LICENSE AUTHORITY FILE COPY  
UNITED STATES  
NUCLEAR REGULATORY COMMISSION  
WASHINGTON, D. C. 20555  
October 8, 1986

The Commission has issued the enclosed Amendments Nos. 151, 151, and 148 to Facility Operating Licenses Nos. DPR-38, DPR-47 and DPR-55 for the Oconee Nuclear Station, Units Nos. 1, 2 and 3. These amendments consist of changes to the Station's common Technical Specifications (TSs) in response to your request dated June 30, 1986, as superseded September 2, 1986.

SAFETY EVALUATION BY THE OFFICE OF NUCLEAR REACTOR REGULATION  
SUPPORTING AMENDMENT NO. 151 TO FACILITY OPERATING LICENSE NO. DPR-38

OCONEE NUCLEAR STATION, UNITS NOS. 1, 2 AND 3

OPERATIONAL POWER  
 IMBALANCE ENVELOPE  
 FROM 0 EFPD TO EOC  
 UNIT 2

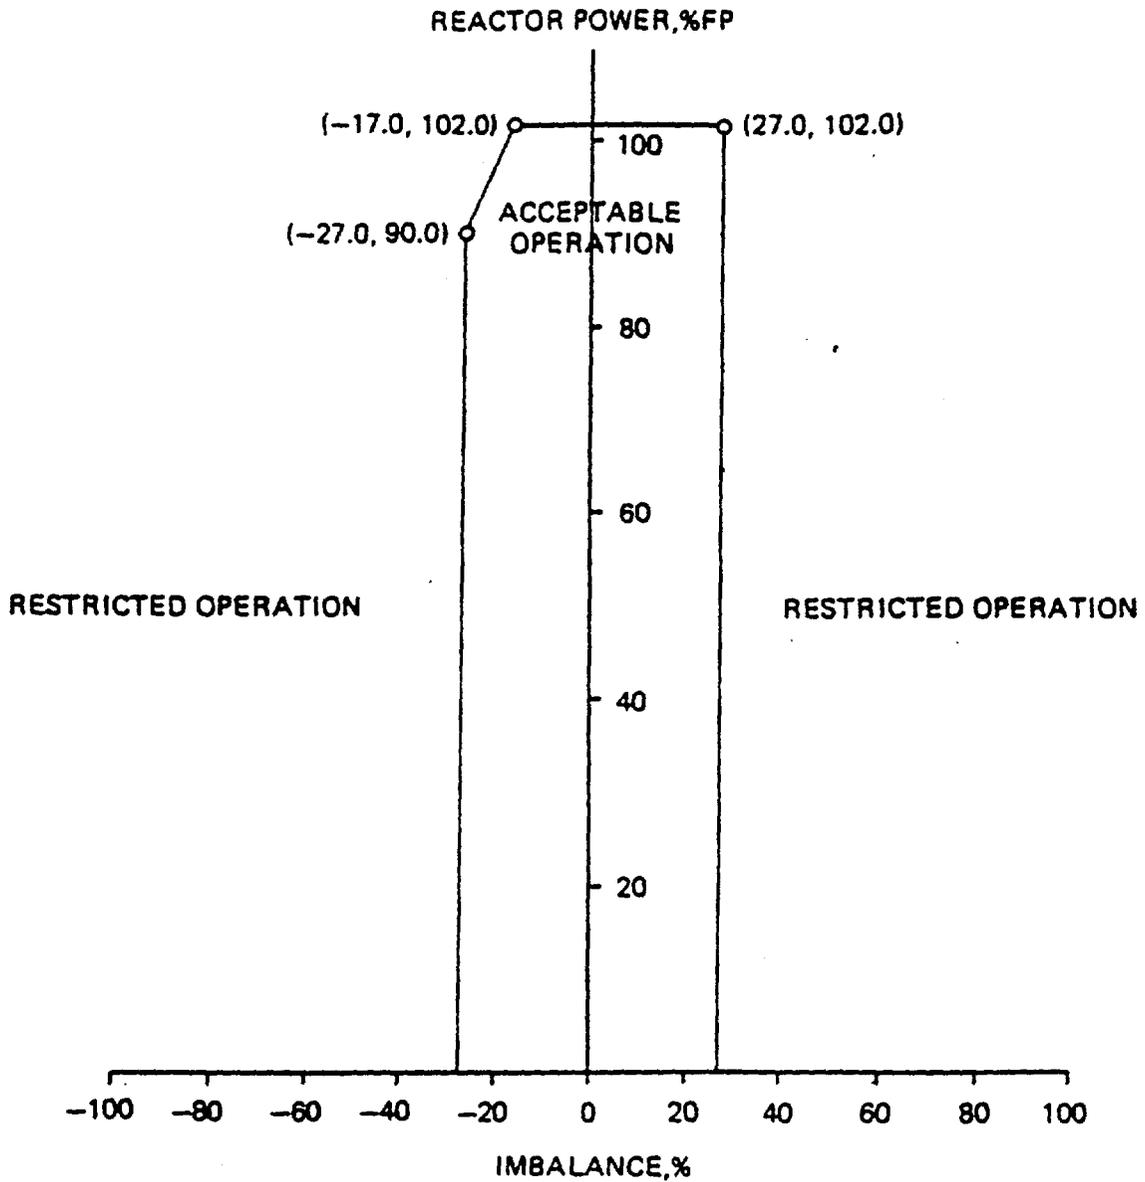
These amendments would authorize proposed changes to the Oconee Nuclear Station TSs which are required to support the operation of Oconee Unit 2 at full rated power during the upcoming Cycle 9. The proposed amendments would change the Power Imbalance Limits (TS 3.5.2).

Oconee Unit 2 Cycle 9 TSs have been modified to account for normal cycle-to-cycle fuel changes in power peaking and control rod worths. The NRC staff reviewed the proposed specification revisions for Cycle 9. These changes concern the Operational Power Imbalance Envelope of Specification 3.5.2. On the basis that approved methodology was used to obtain these limits which assure that General Design Criteria 10 and 12 are satisfied, the NRC staff finds these TS modifications acceptable.
